Comment Resolution related to 4x4 MIMO Practicality (CID 69)

IEEE P802.22 Wireless RANs

Date: 2014-03-18

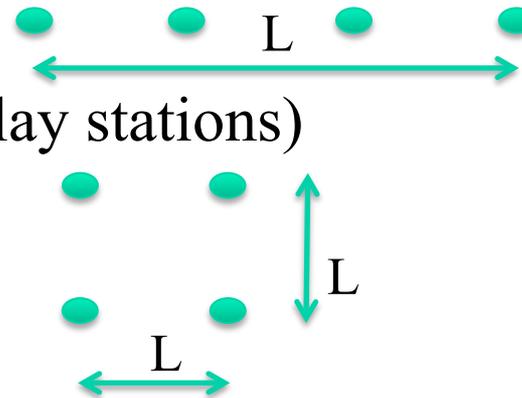
ID	Comment	Suggested Remedy
69	Due to the physical size of the antennas in the VHF and UHF TV broadcast bands, the use of 4 x 4 MIMO will very likely be limited.	Consider the added complexity to the proposed standard and the probability of use of such technology in practice.

- 4x4 ULA (Terminals, Low relay stations)
 - $L = 0.75$ meter
- 4x4 URA (Terminals, Low relay stations)
 - $L = 0.25$ meters

For the case of low height antennas, the array length for 4 antennas is obviously practical.
